**U.S. Department of Energy
Office of Environmental Management**

Review Report: Feasibility Study Strategies and Remedial System Performance Improvement for the 200- ZP-1/PW-1 Operable Units at Hanford

February 9, 2007

Figure 5.1. Schematic illustrating suggested remedial approach

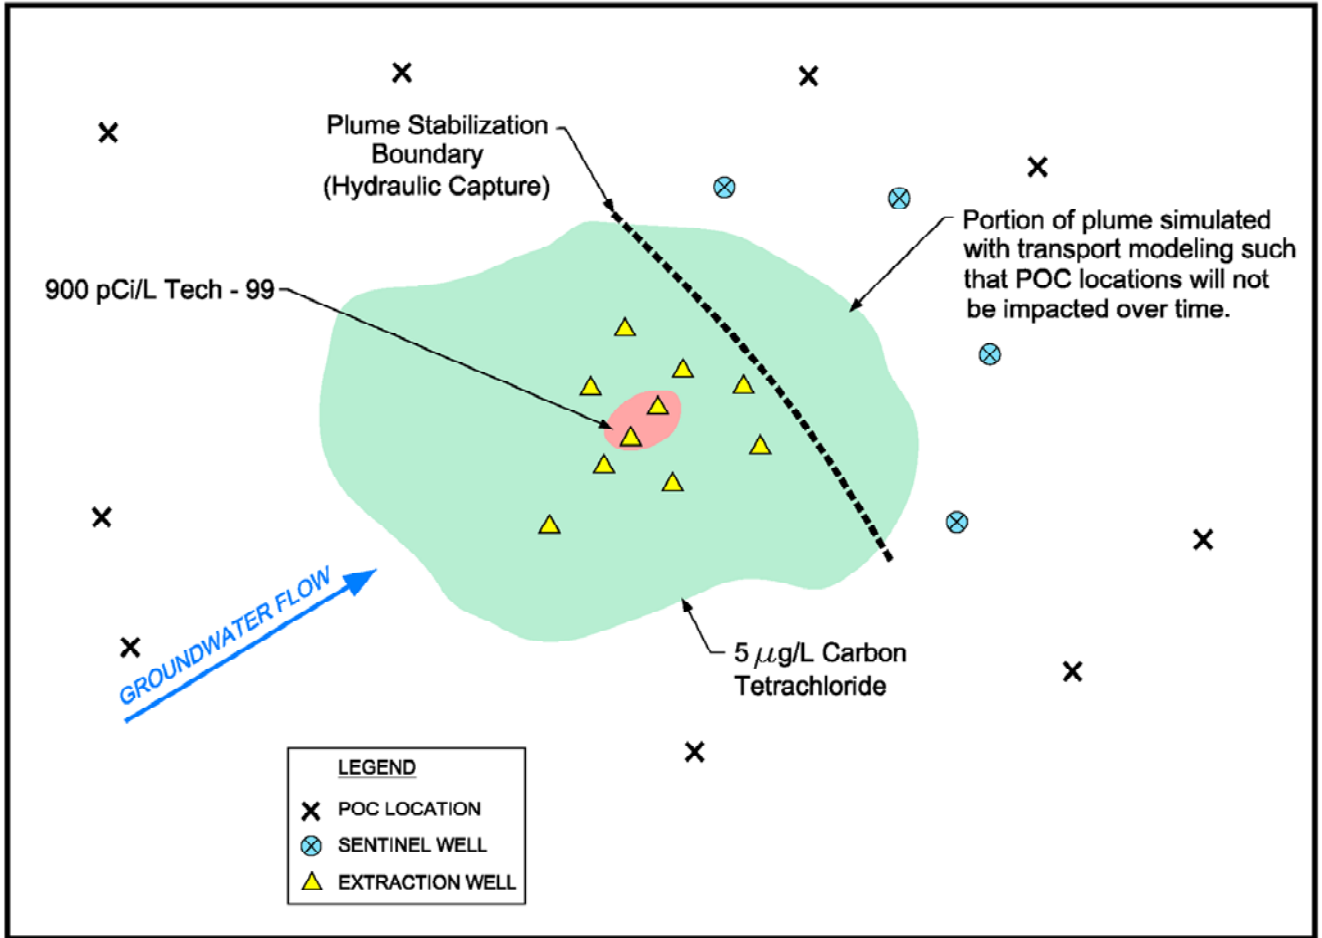
The FS may include consideration of several P&T approaches. For instance, one approach might include hydraulic containment for the full extent of the CT plume above cleanup levels. An alternate approach that may require much less capital and life-cycle cost is hydraulic containment of the most impacted portion of the CT plume, with natural remediation for the portion of the plume beyond the zone of hydraulic containment. This latter approach is schematically illustrated in Figure 5-1. The Review Team believes this latter approach will be evaluated favorably within the FS, to the extent that a combination of modeling and monitoring is incorporated to demonstrate long-term protectiveness at point of compliance (POC) locations.

Deciding on a specific boundary for the zone of hydraulic containment, the Target Capture Zone, will consider several factors:

- The Target Capture Zone should be located beyond any locations where potential DNAPL is suspected. In this manner, the groundwater downgradient from the zone of hydraulic containment should decrease in contaminant concentration over time by reducing source contribution through hydraulic containment.

- The Target Capture Zone should specify depths, or hydrostratigraphic units, where horizontal capture is required. Specifically, the Review Team noted that contamination within the Ringold Unit A, below the Ringold Lower Mud Unit, was not clearly indicated in some presentations regarding contaminant distribution. The Target Capture Zone should clearly indicate the extent to which horizontal capture in this unit is required.

- Contamination downgradient of the Target Capture Zone, CT and other contaminants, should attenuate to cleanup levels before reaching the POC locations (selection of POC locations is discussed below). For the FS, the Review Team recommends the use of simple transport models (see Section 5.3.3) to evaluate attenuation of contaminant concentrations between the Target Capture Zone and the POC locations. This exercise will help establish an appropriate location for the boundary of the Target Capture Zone, which combines an acceptable combination of distance to the POC locations and acceptable initial concentration outside the Target Capture Zone.

As discussed in Section 5.2.3, one remedial approach favored by the Review Team is to use groundwater extraction for hydraulic containment of the most impacted portion of the CT plume, with natural remediation for the portion of the plume beyond the zone of hydraulic containment (schematically illustrated previously in Figure 5.1).
